**ADDENDUM NO. 1**

**CID 01-STILLHOUSE BRANCH WASTEWATER TREATMENT FACILITY  
IMPROVEMENTS**

**PROJECT NO.: 2-01590 | TWDB CWSRF NO. 73776**

**DATE OF ADDENDUM: MAY 24, 2023**

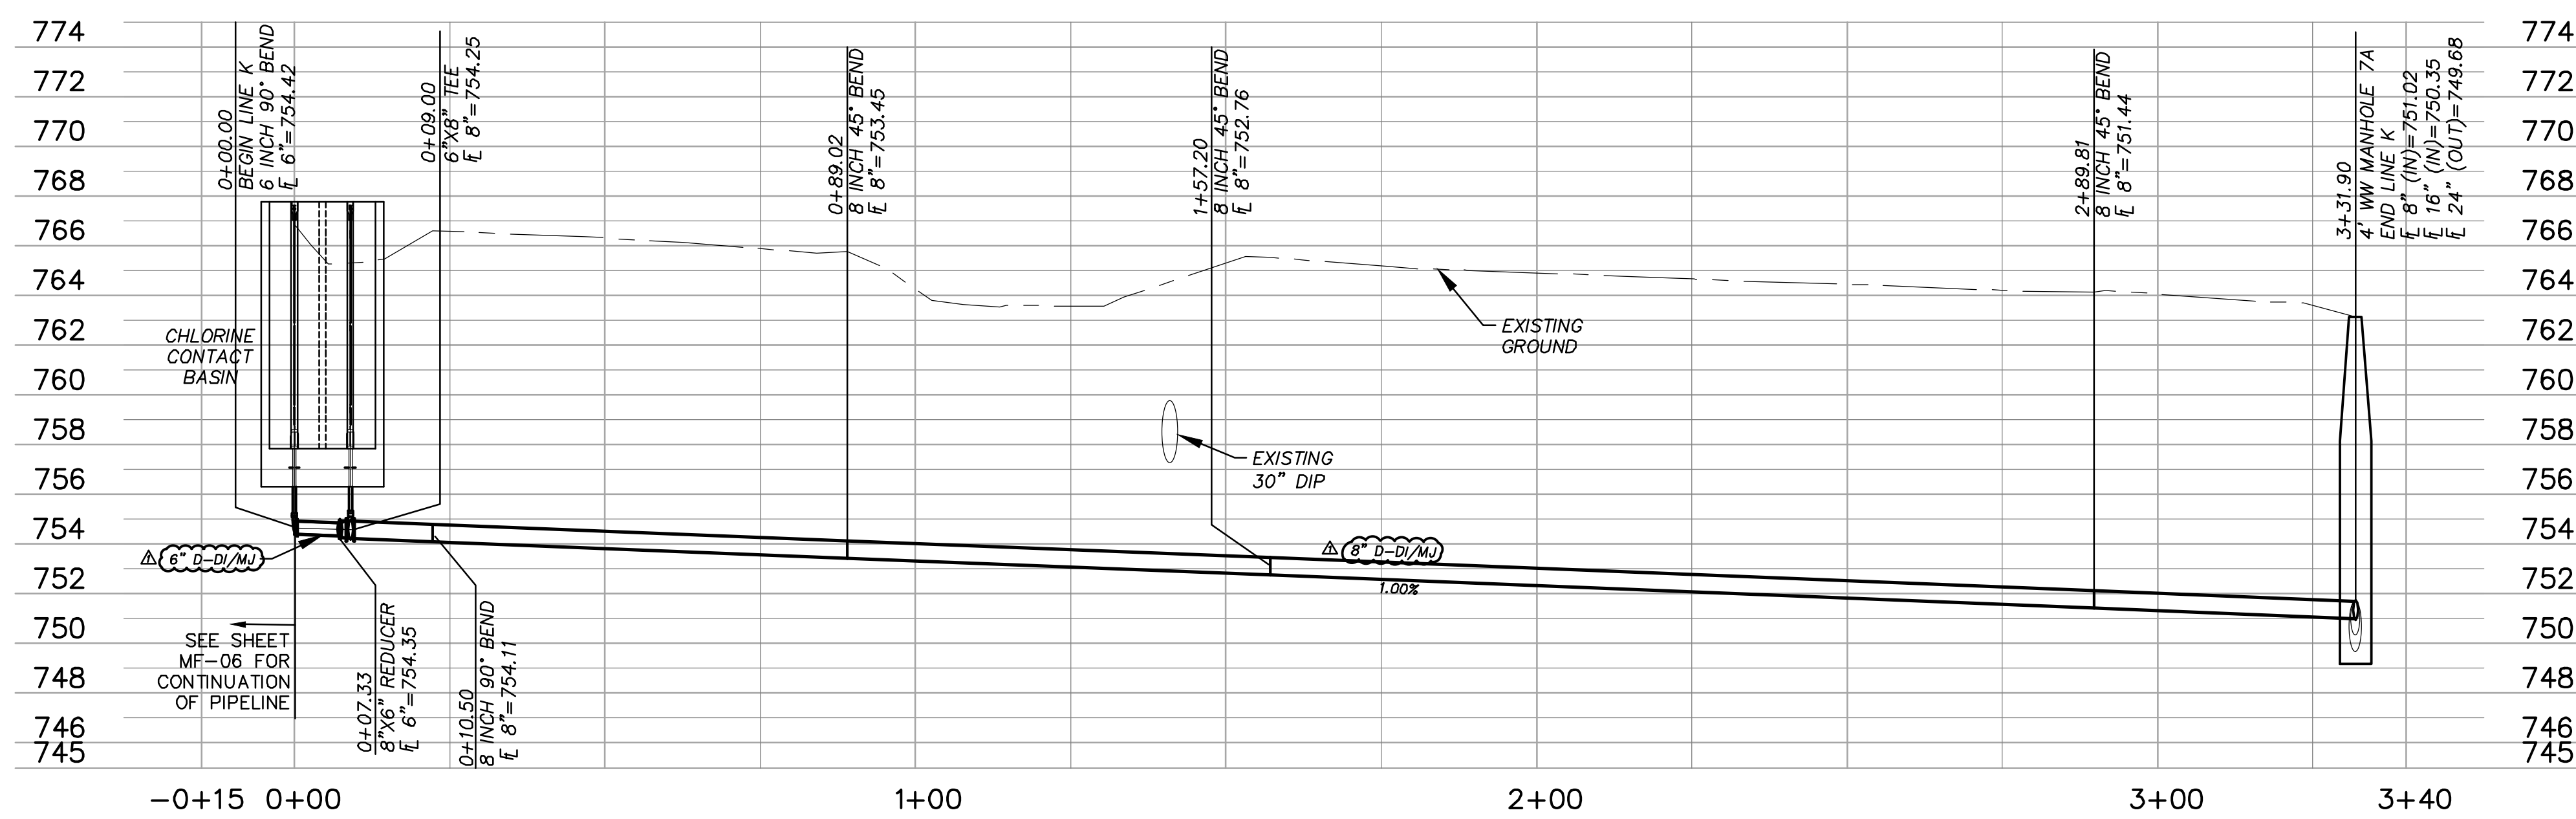
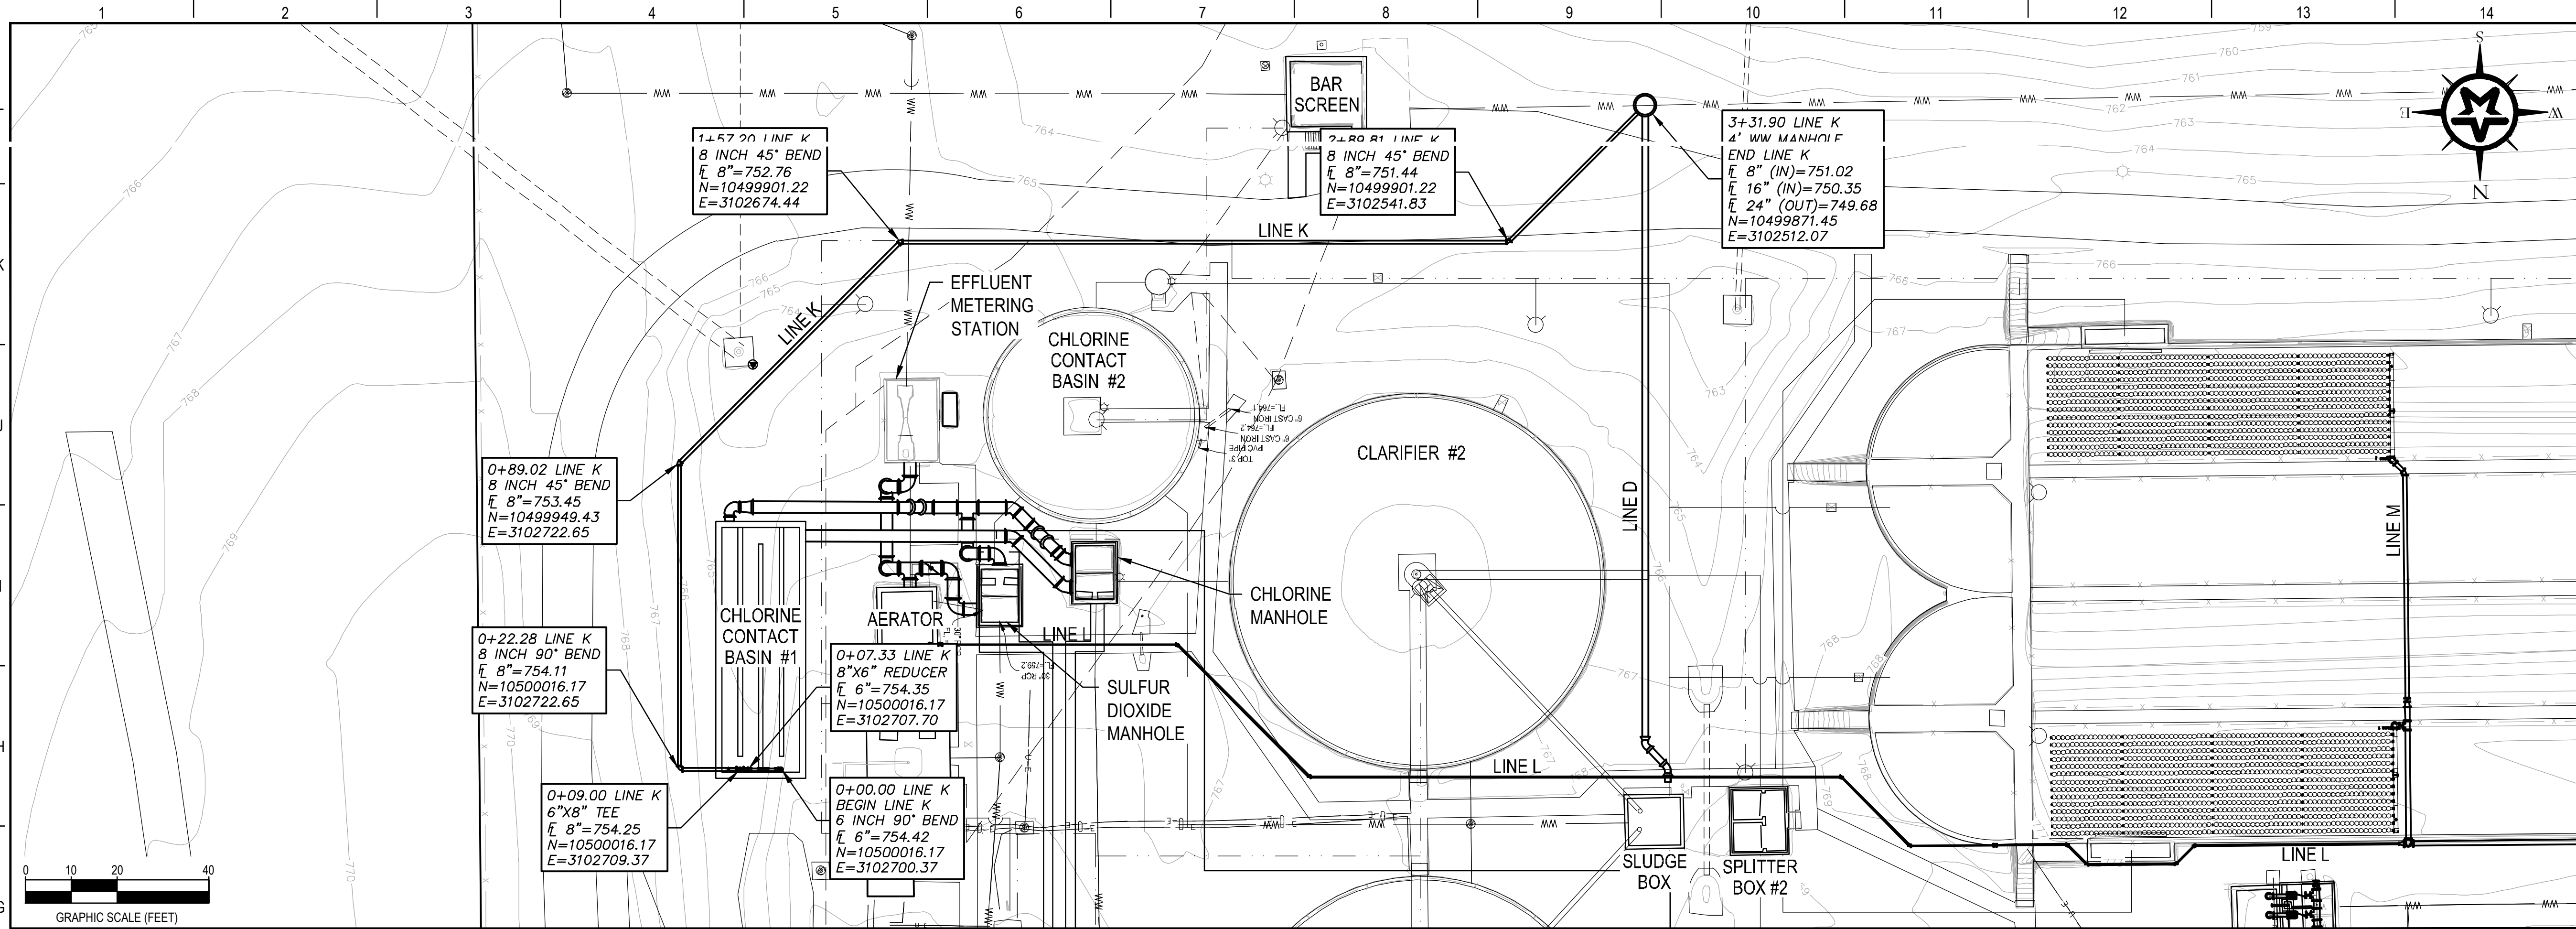
a. Sheets C-08 through C-17

REVISE yard piping to reflect the pipe labels on Sheet M-01 and Sheet M-02.

DRAWING NO. **M-02**

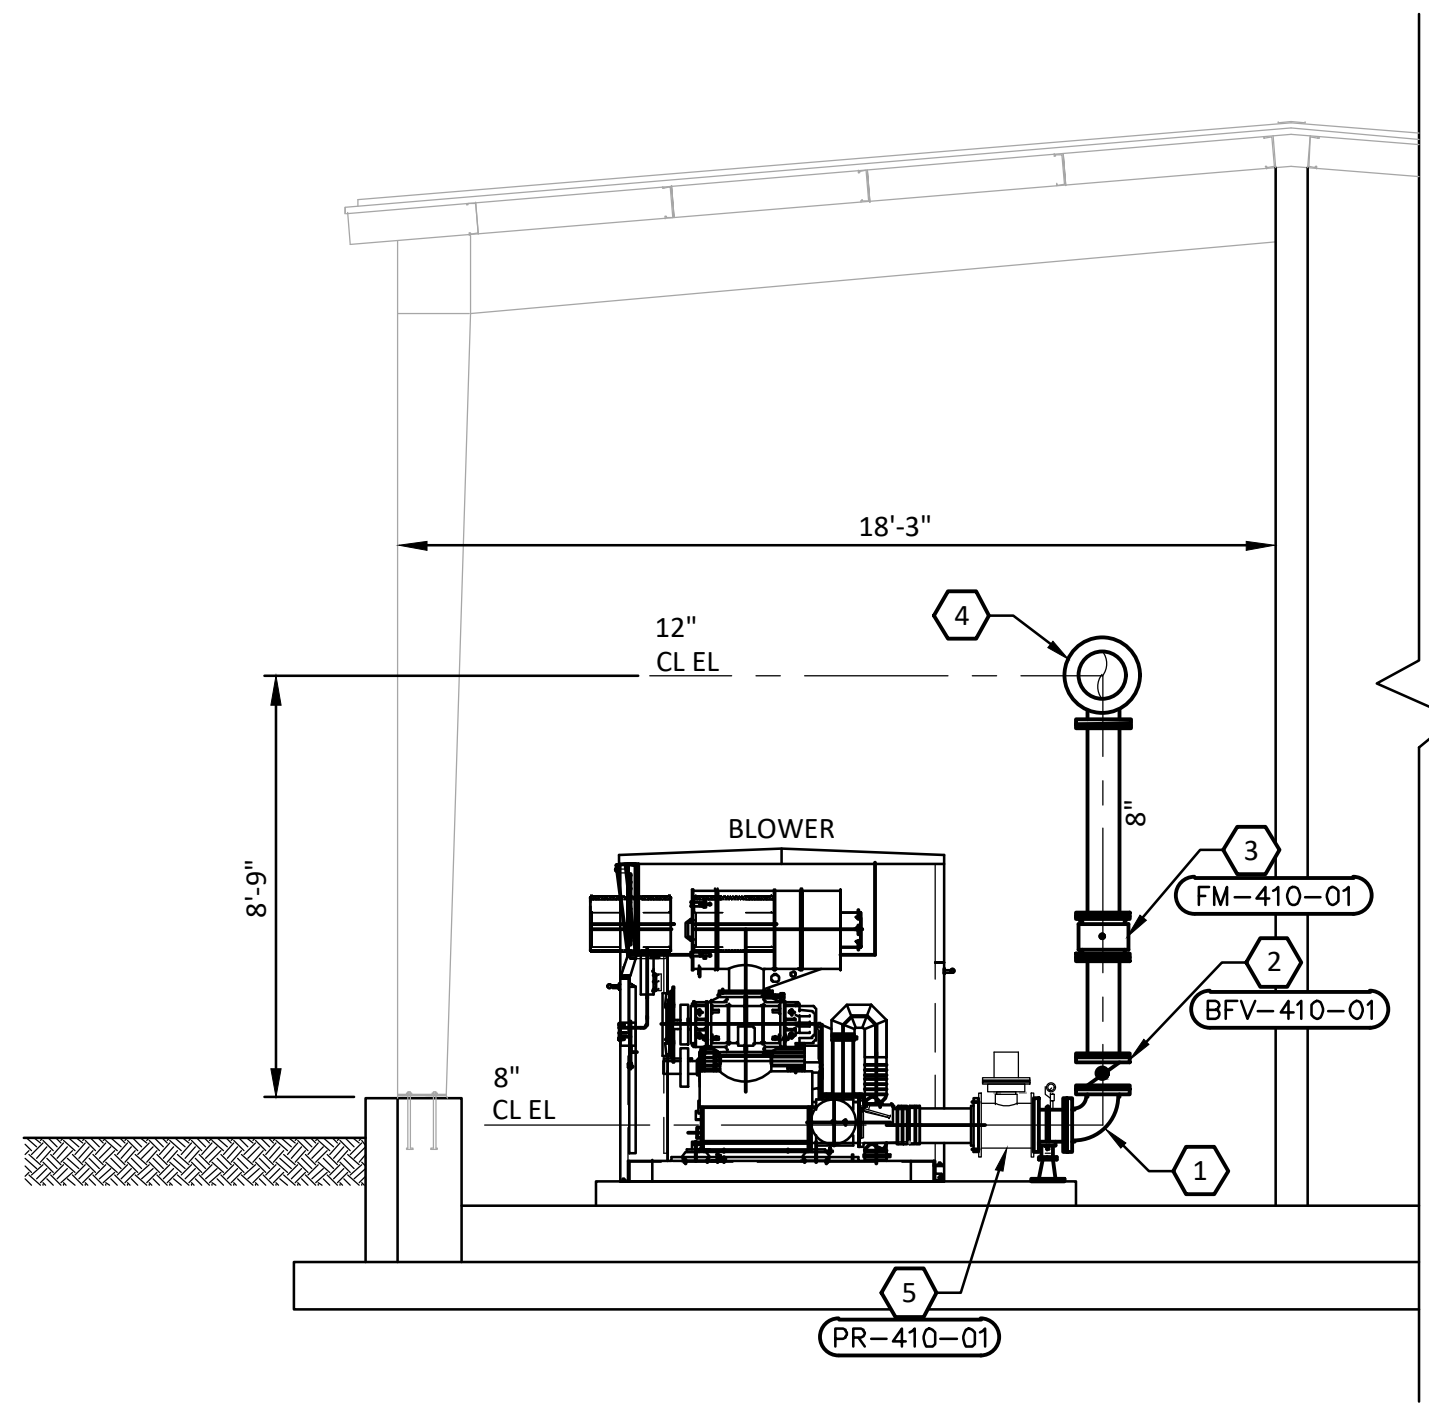
d. Sheet M-02

REVISE to match the yard pipe labels.

DESIGNED	J. JENKINS
DRAFTED	M. CLOUGH
CHECKED	TFG, PA
PROJECT NO.	J. JENKINS
	2-01590
DRAWING NO.	
<b>MJ-03</b>

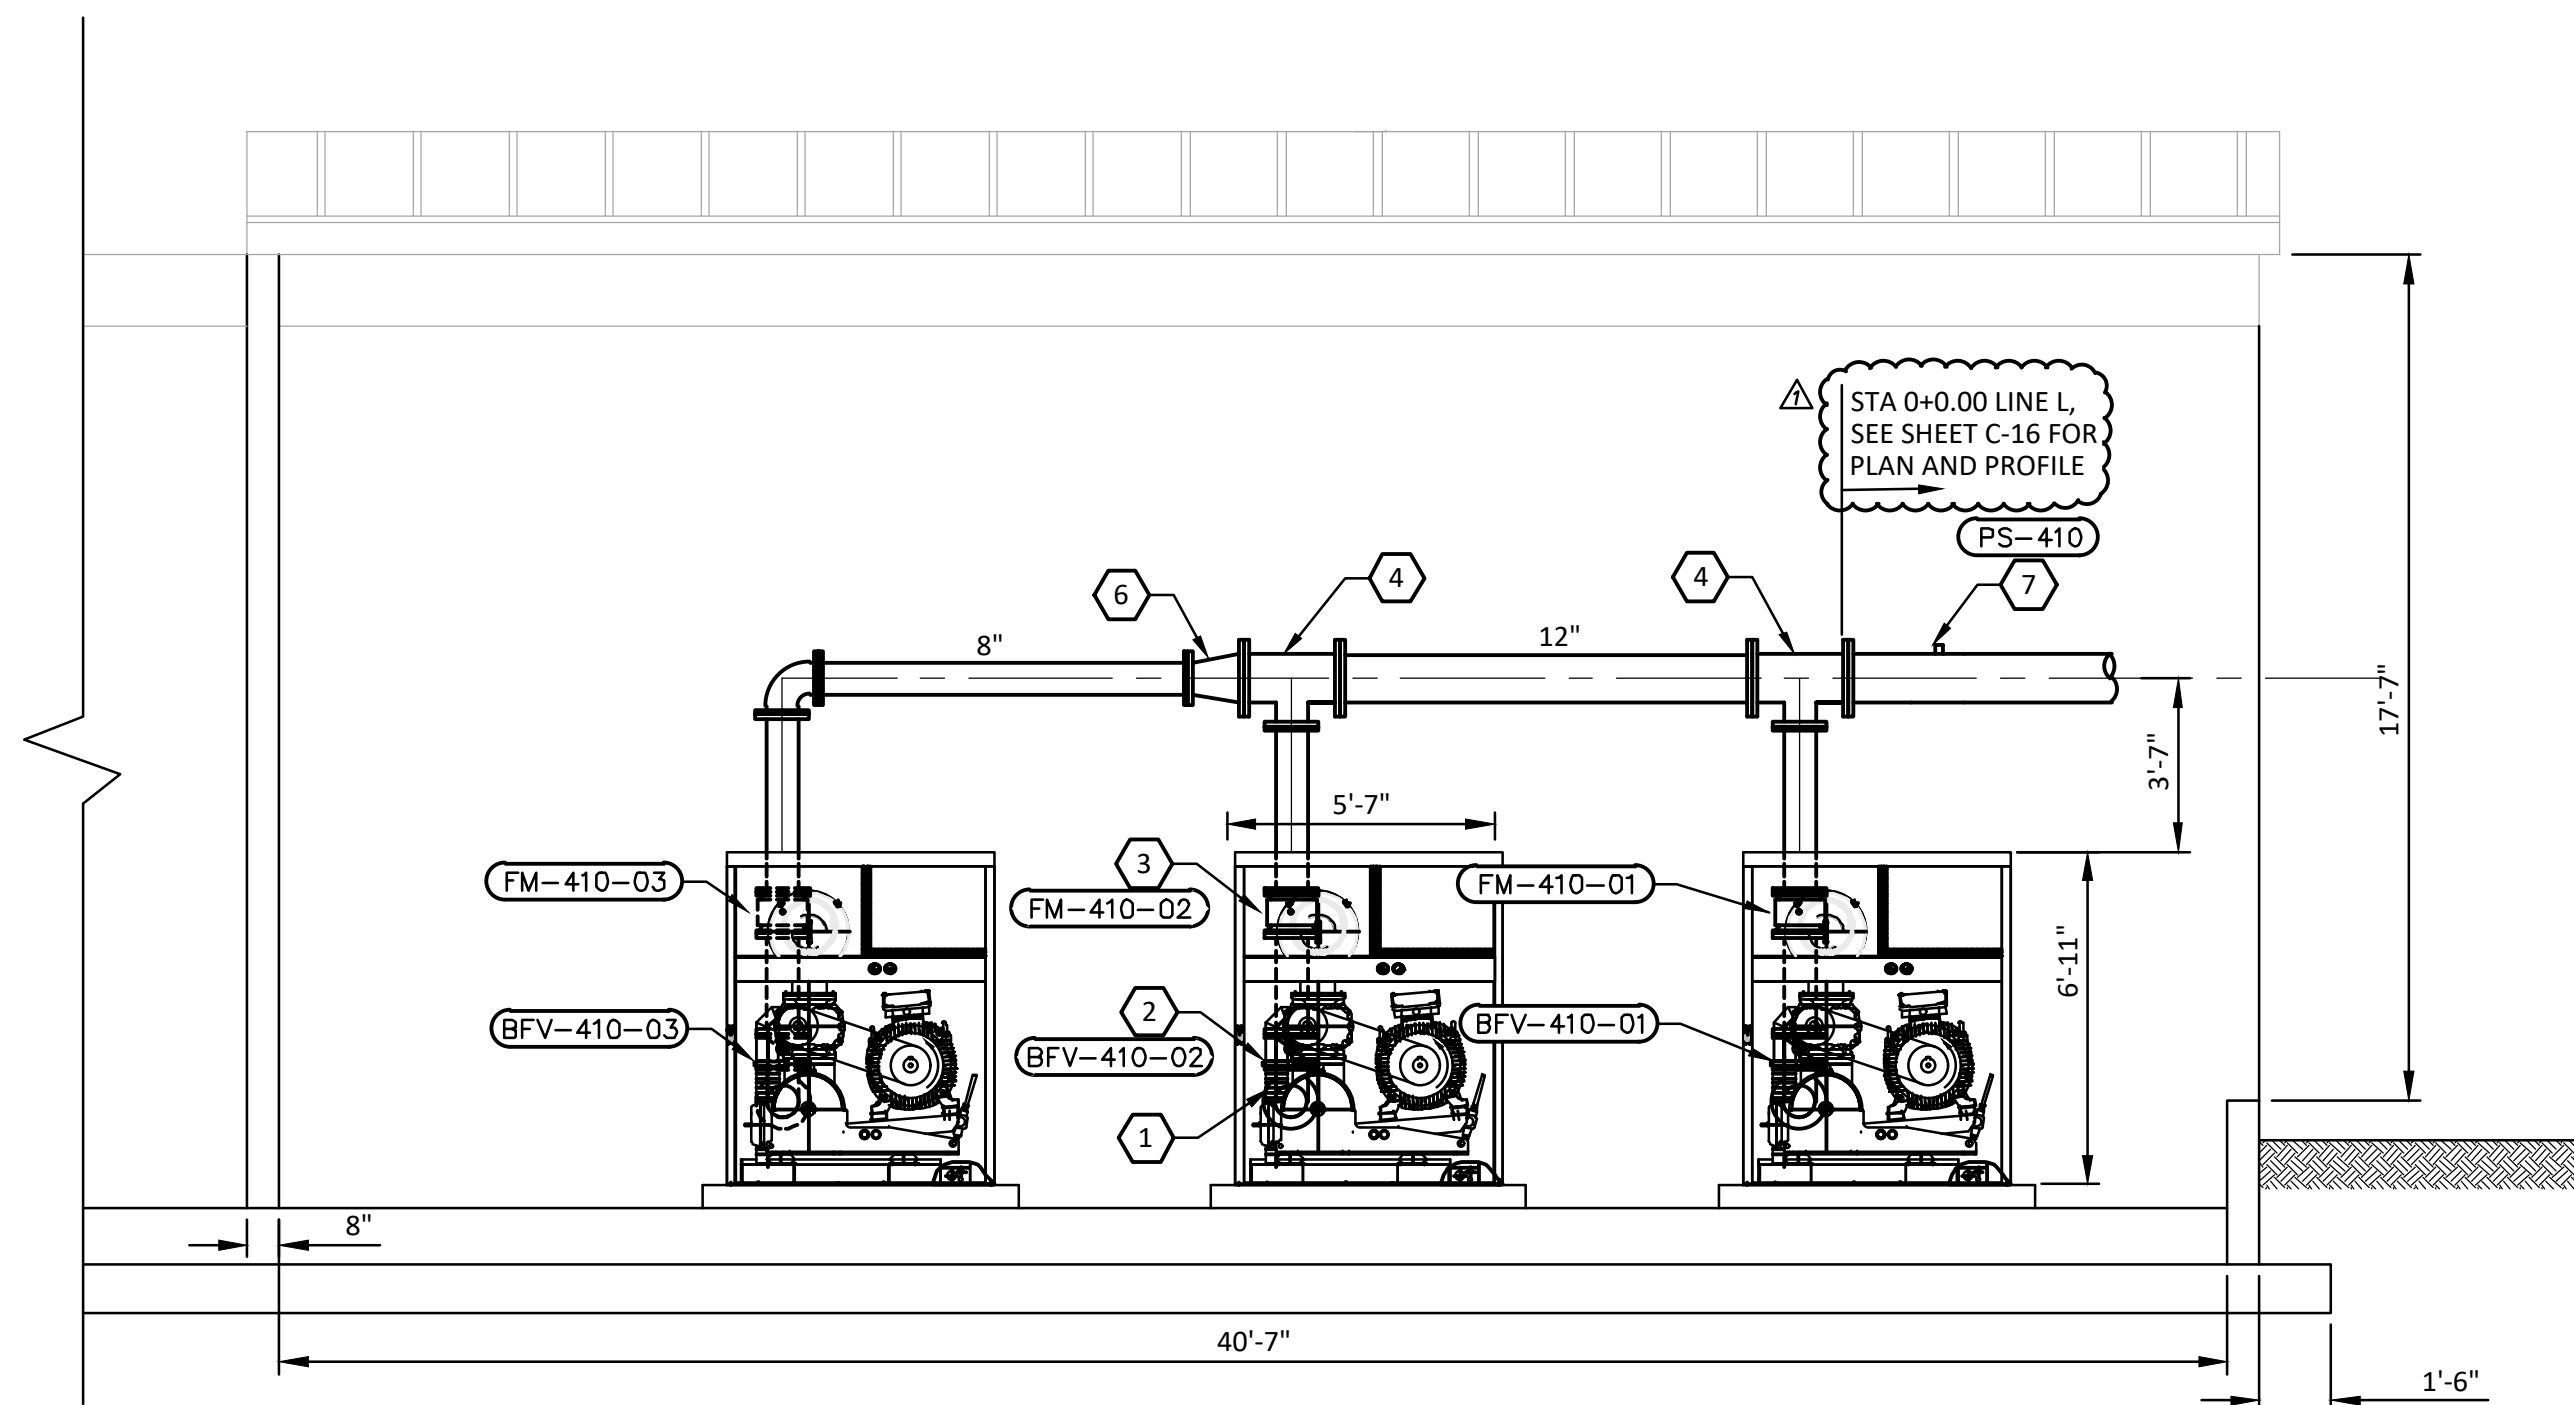
e. Sheet MJ-03

REVISE Sheet MJ-03 Note to state "Sheet C-16" instead of "Sheet C-20".
